STATE OF NORTH CAROLINA
DEPARTMENT OF TRANSPORTATION

December 5, 2023

Addendum No. 1

RE: **DD00440**
Halifax County

TYPICAL SECTION NO. 1

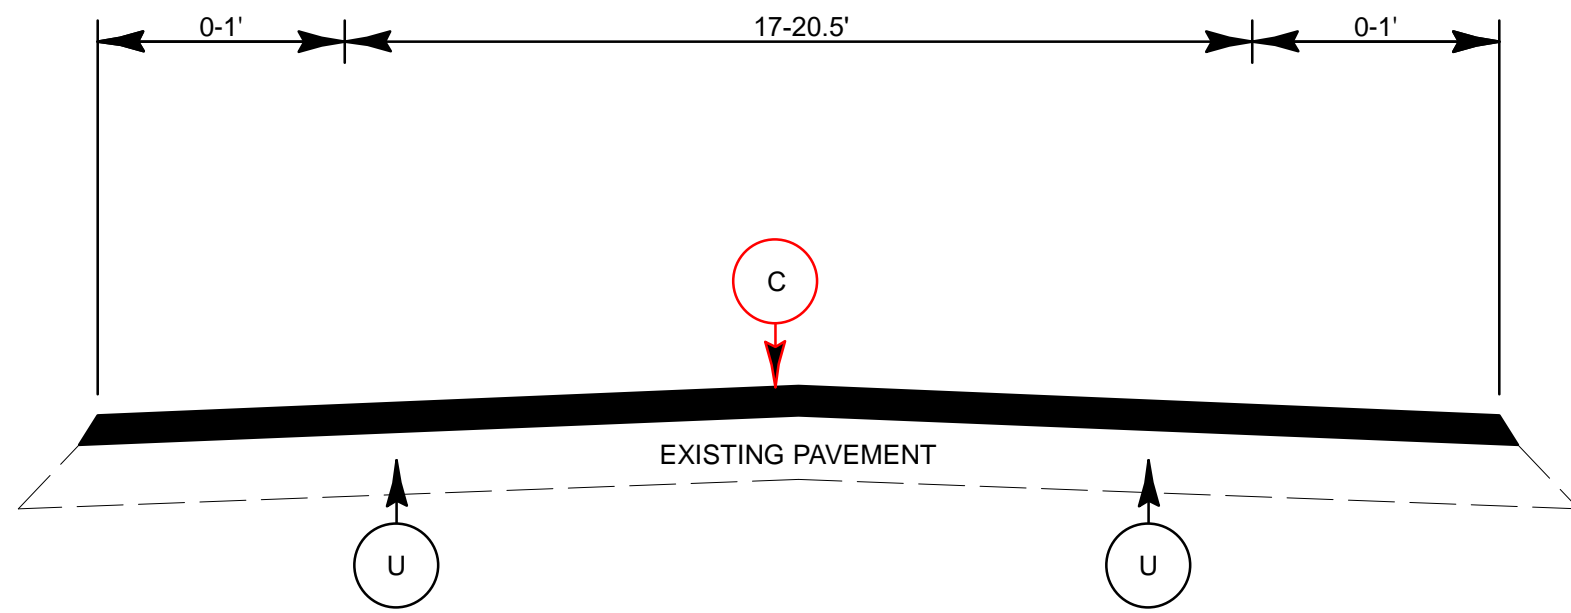
1. The Typical Sections on page 66 of the proposal do not correspond to the typical listed on the summary of quantities. Typical 1 should show that AST is to be placed on maps 1 – 4 and Typical 2 should show paving using S4.75A on maps 5 - 15. Please replace the Typical Section page in the proposal with the attached page.
